July 14, 1999

This letter is to request a review of several changes planed to the Metorex SIPS probe which is currently covered by Registry NR-0701-D-104-B. These modifications are in the latter stages of design and evaluation but have not yet been formalized. These changes will be implemented in the fall of 1999 and will occur in all probes. Thus, these modified probes will be identified by a serial number greater than a certain number that will be determined at a later date.

## **Modifications to SIPS Probe NR-0701-D-104-B**

Attachment 1A

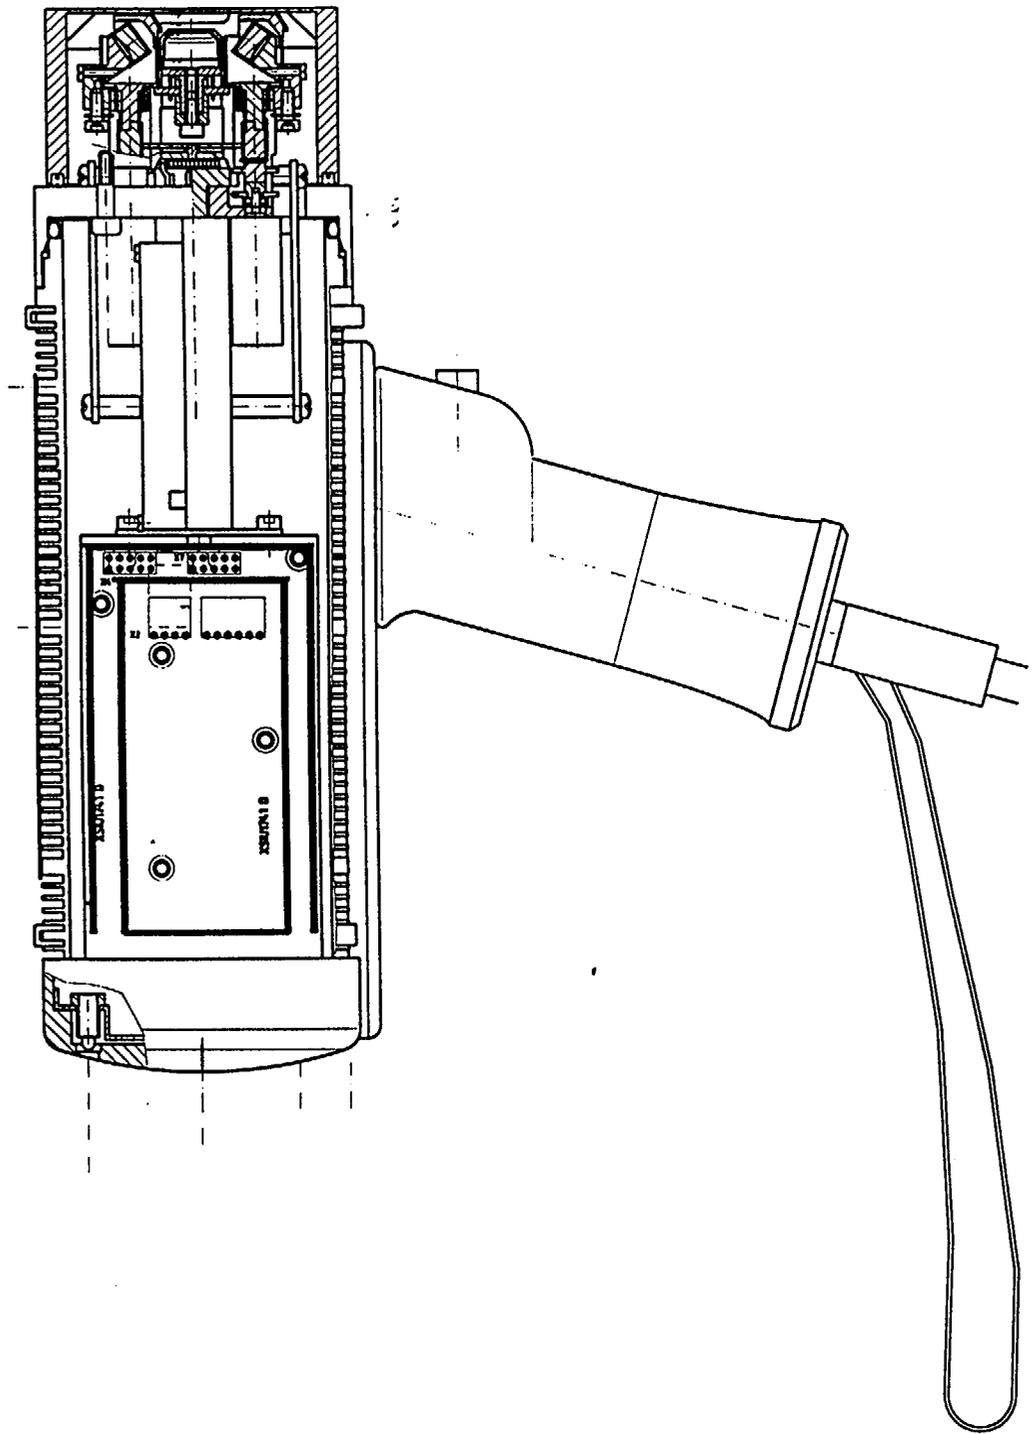
Attachment 1A (p3) is a drawing of the redesigned probe. Two external modifications have been made to the probe. First, three of the grooves in the body of the probe have been eliminated. This provides a more secure mounting for the screws that hold the radiation warning label. The second change is that a new handle has been designed which better fits the grip and includes a safety strap to minimize the chance of dropping the probe. In addition, the probe cable now enters the probe through a connector rather than being hard wired to the probe.

# Attachment 2A

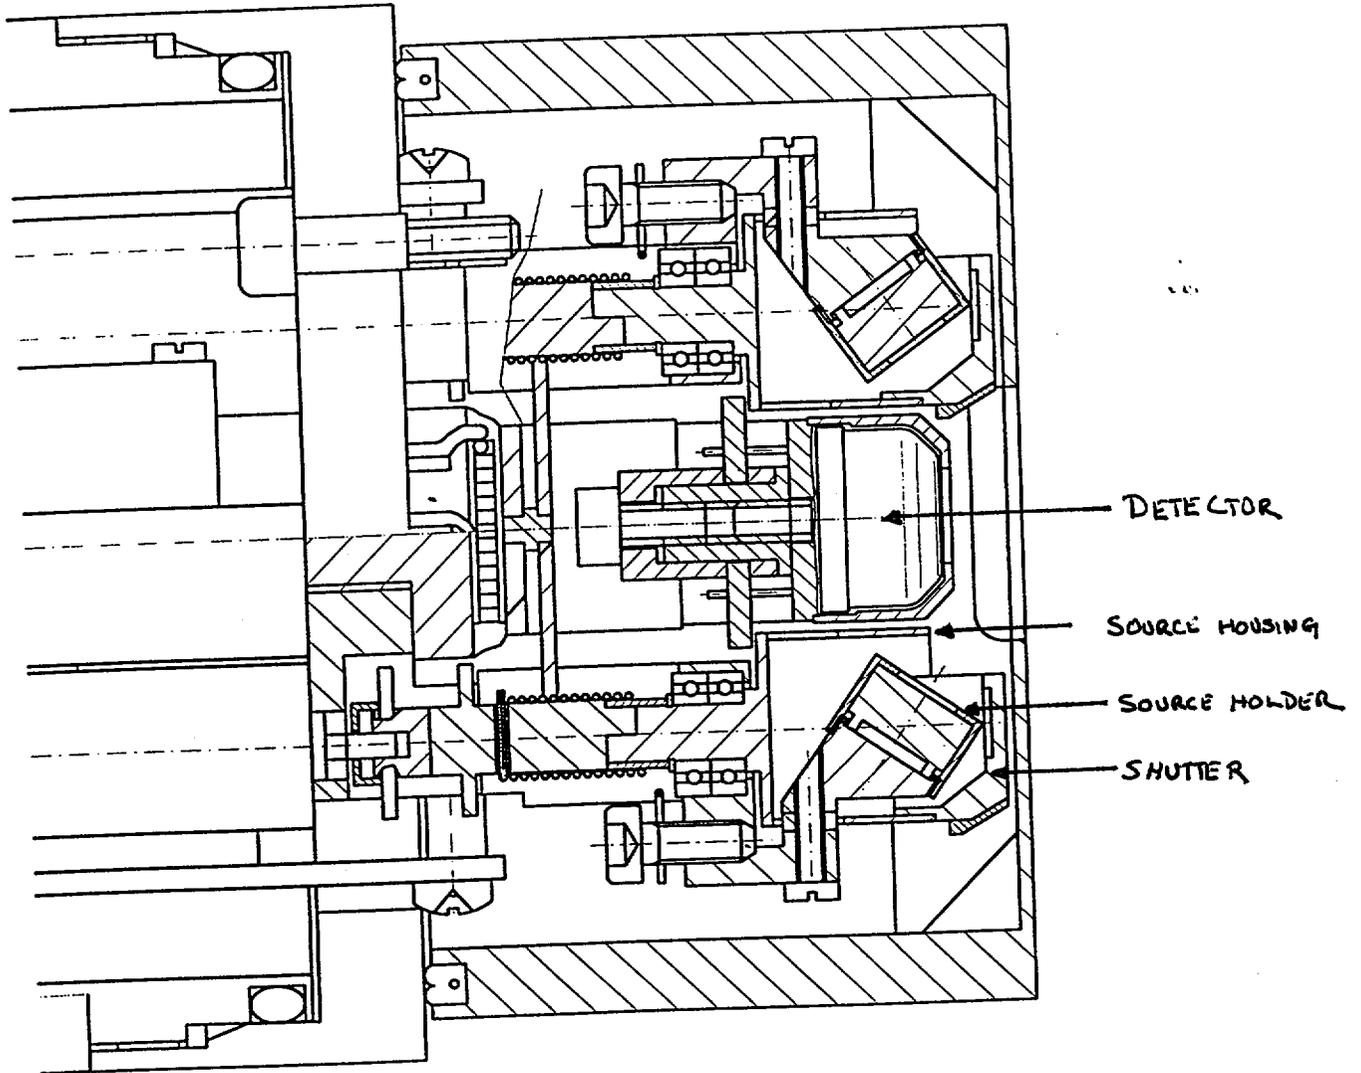
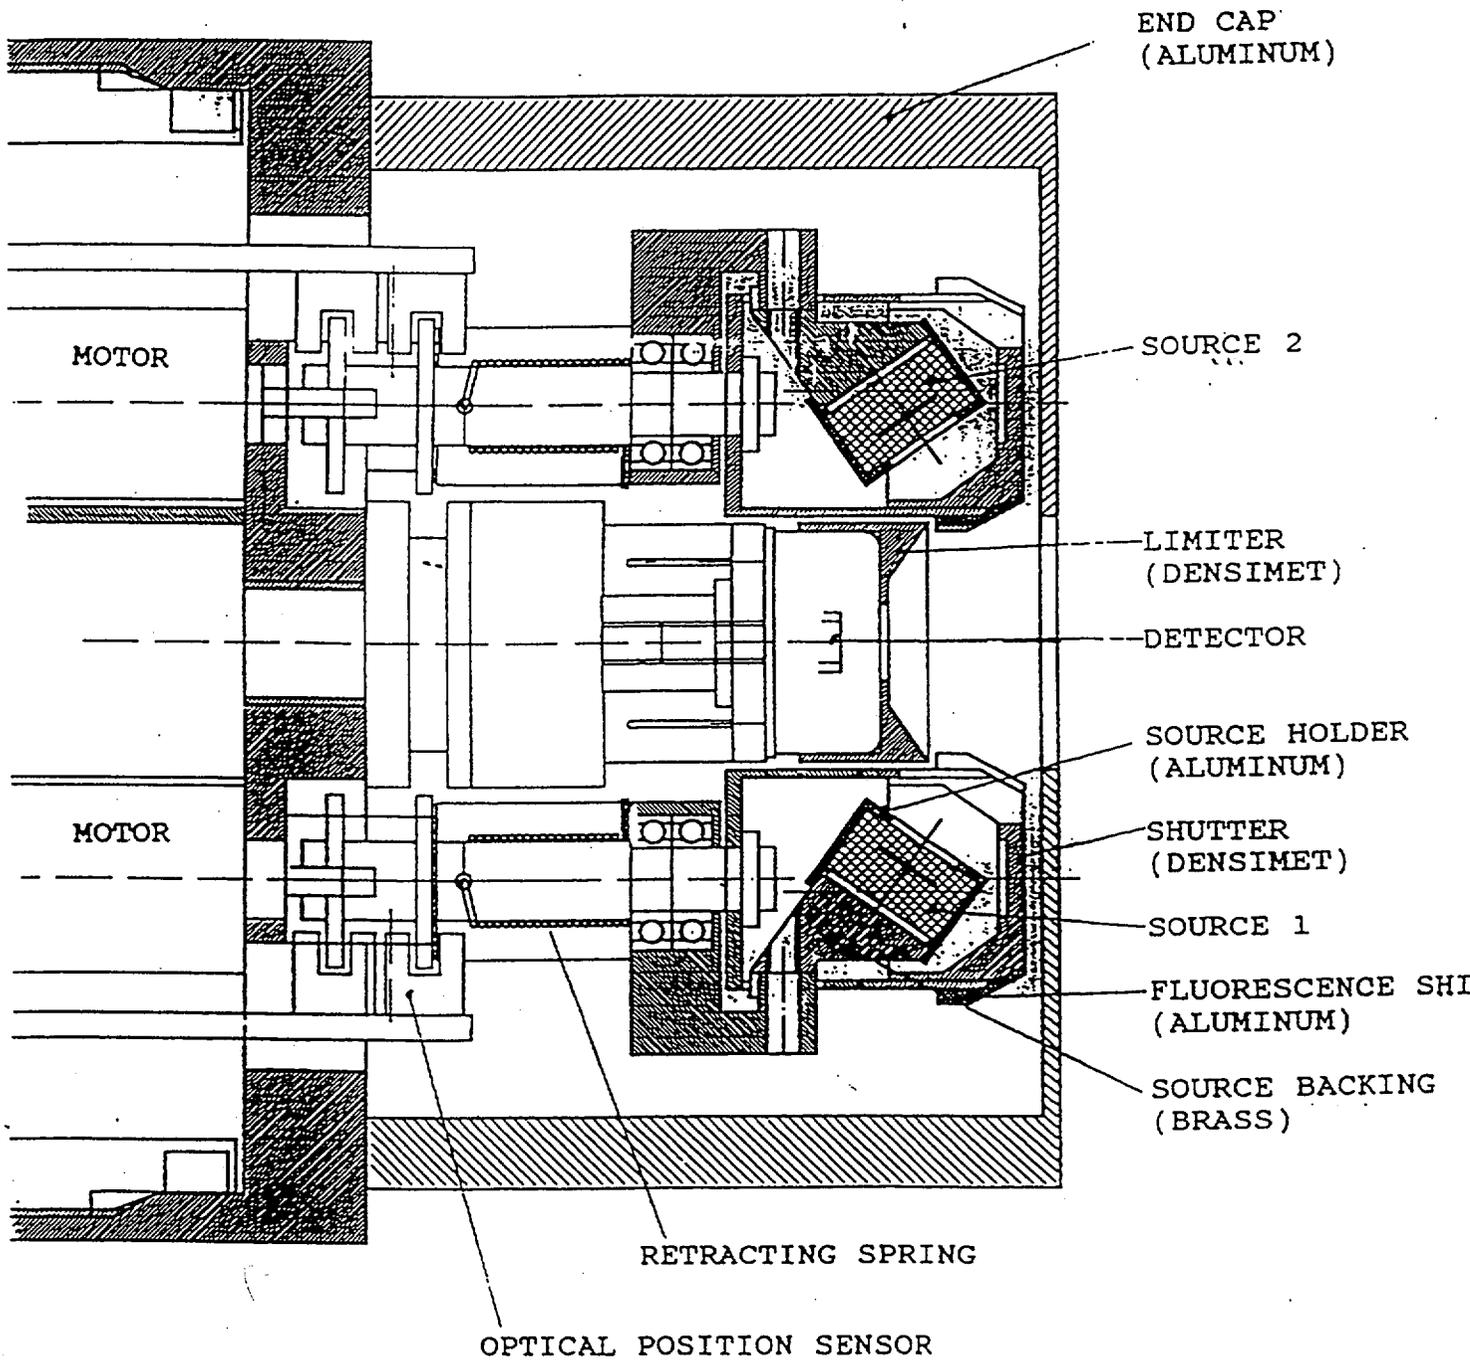
Attachment 2A (p4) shows the modification of the detector geometry. In this view, the lower shutter is opened and the upper shutter is closed. When compared to Attachment 2 (p5) from the registry, the change in the position of the detector can be seen. The detector is much closer to the front of the probe. In order to shield the detector from the source, the source housing has been modified slightly (p6). Thus, the shutter opening is slightly smaller than in the original probe. Otherwise, no changes have been made to the source holder and/or the shutter mechanism.

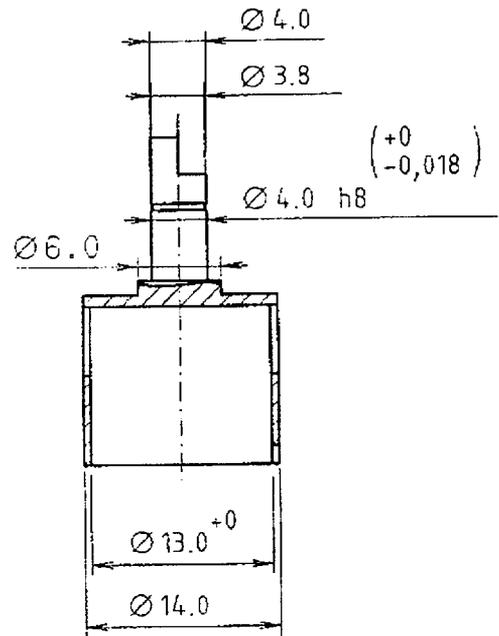
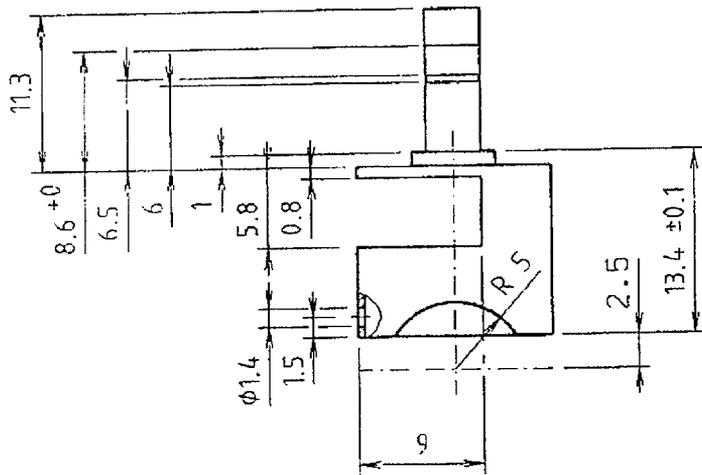
This machining is left away from the new SIPS.

# Attachment 3A

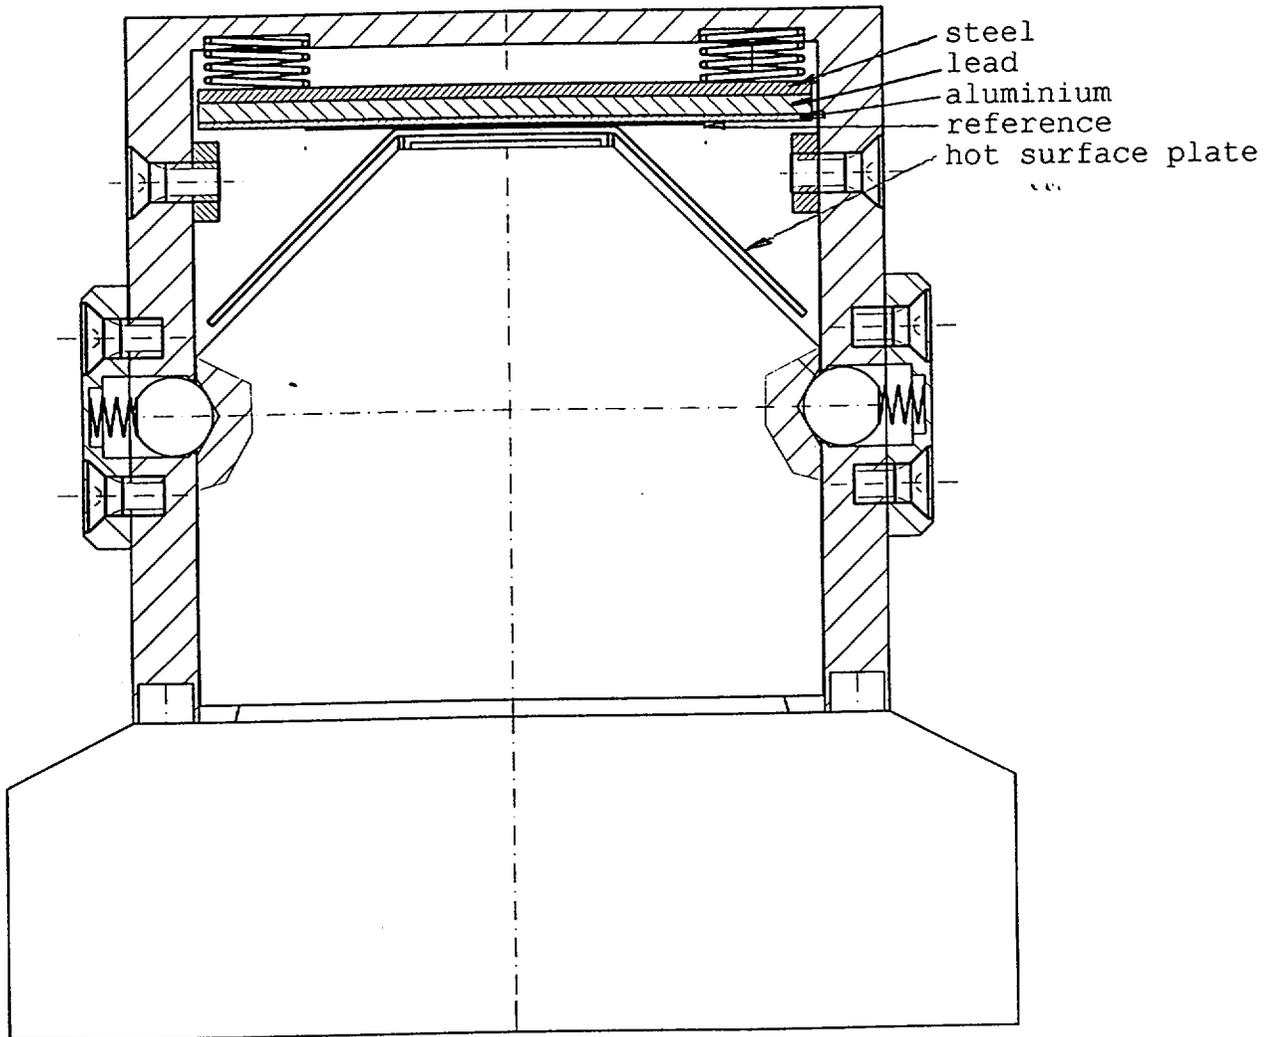
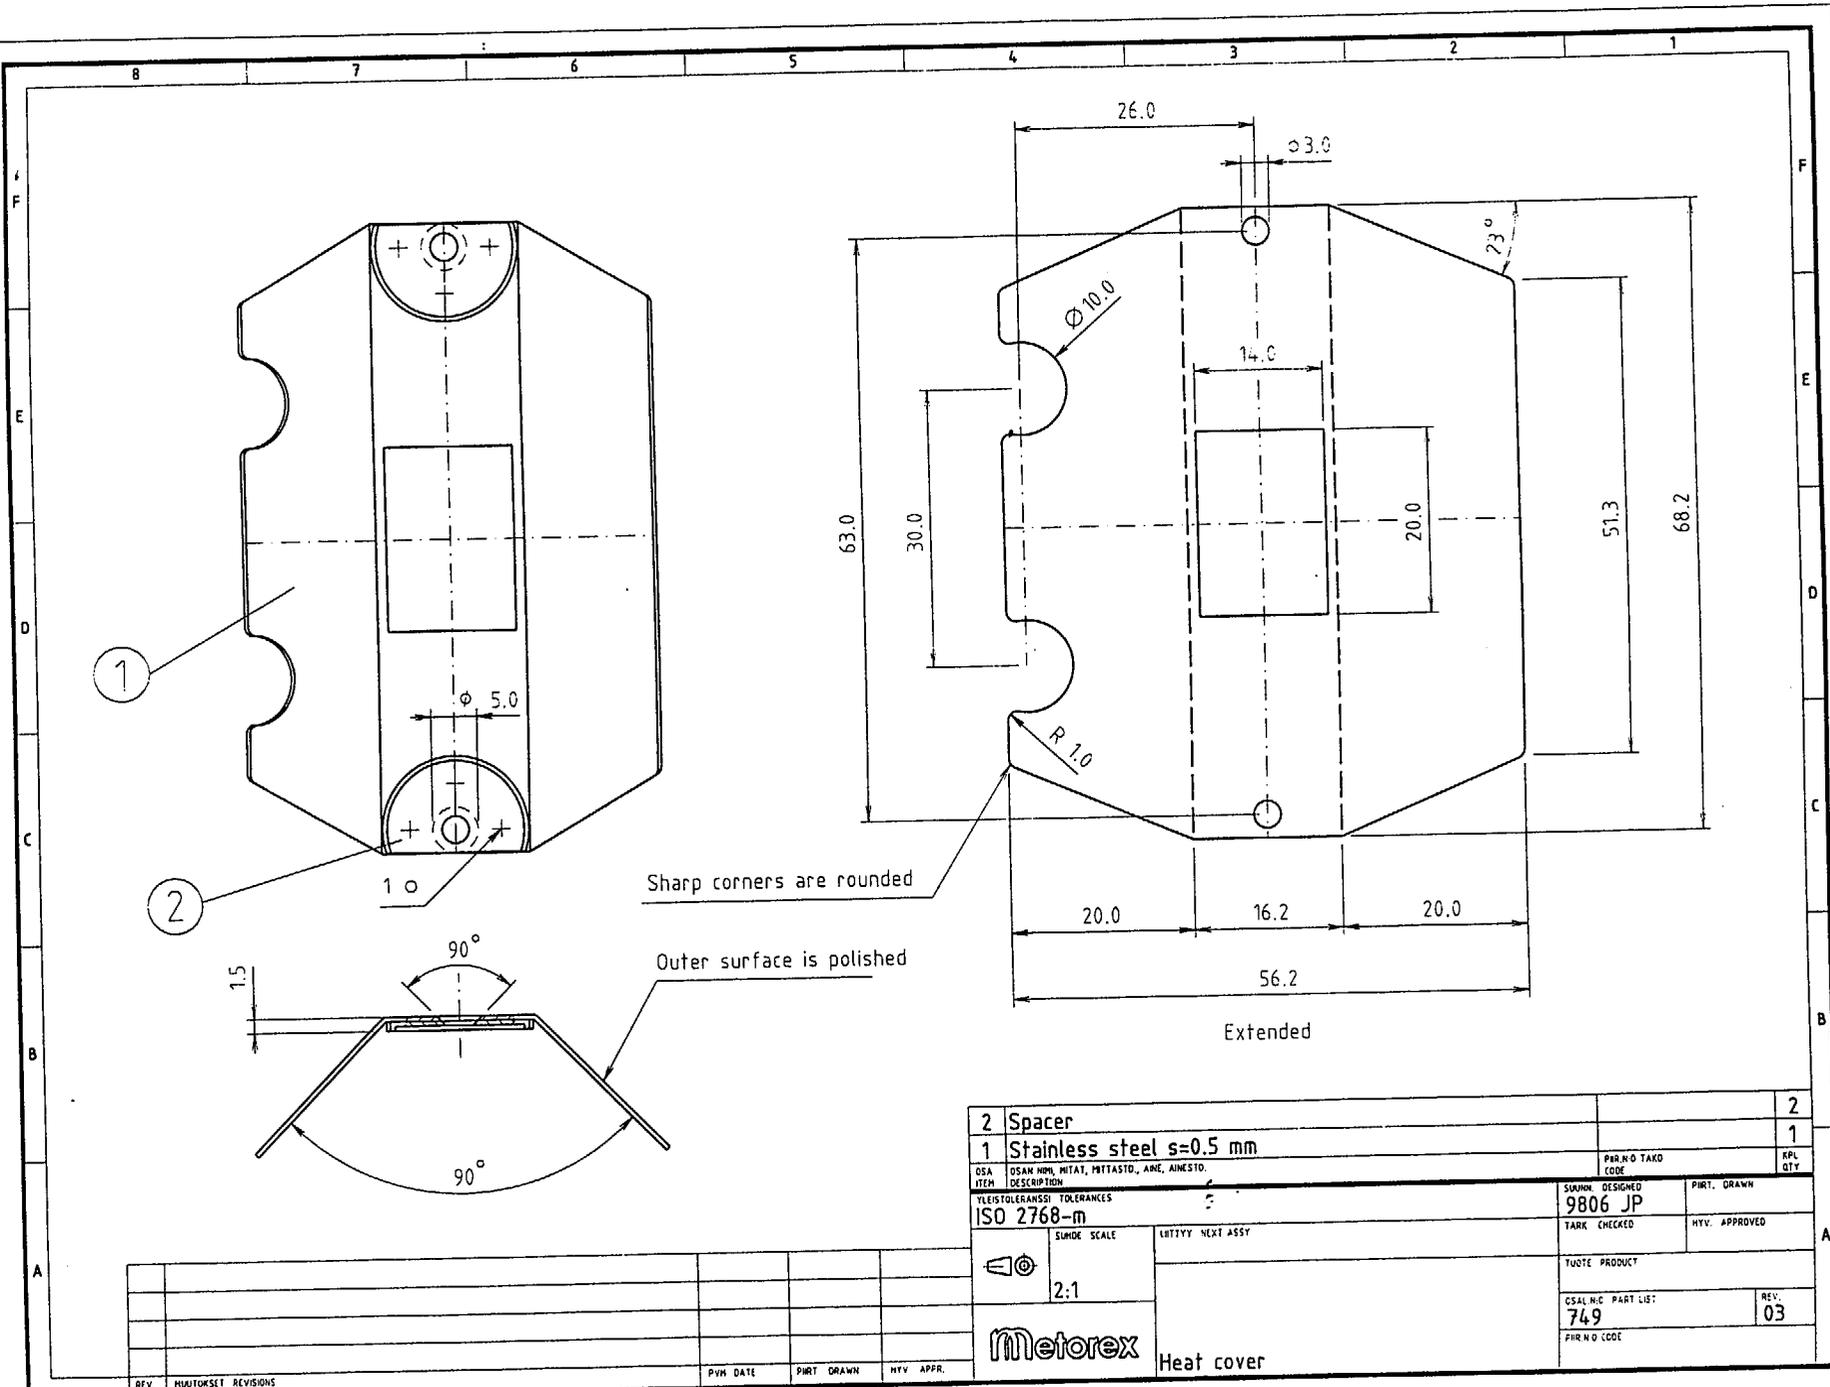
Attachment 3A (p7) illustrates the new heat shield and end cover. The heat shield (Attachment 4; p8) is an option for the unit to allow the probe to be used at elevated temperatures. The shield and associated mounting slightly separate the probe from the sample and provide some insulation. The installation of the heat shield slightly extends the length of the probe snout. Thus, with and without the shield, the probe snout will be of different lengths. This has led to the development of a new end cover. In this version, the cover is fixed onto the probe snout with two spring loaded balls in the side of the cover. These balls fit into the small conical recesses in the probe snout. The cover is slightly longer than the old version and shielding mechanism is floating on four (4) springs. Two (2) bars on the side of the cover limit the outward movement. The same cover is used with or without the heat shield. The shielding mechanism is sandwich composed of a lead sheet between a steel and aluminum sheet. A copper reference sample is attached to the front of the sandwich. The steel plate adds to the shielding provided by the cover when compared with the previous cover.

Sharp corners are rounded

Outer surface is polished

Extended
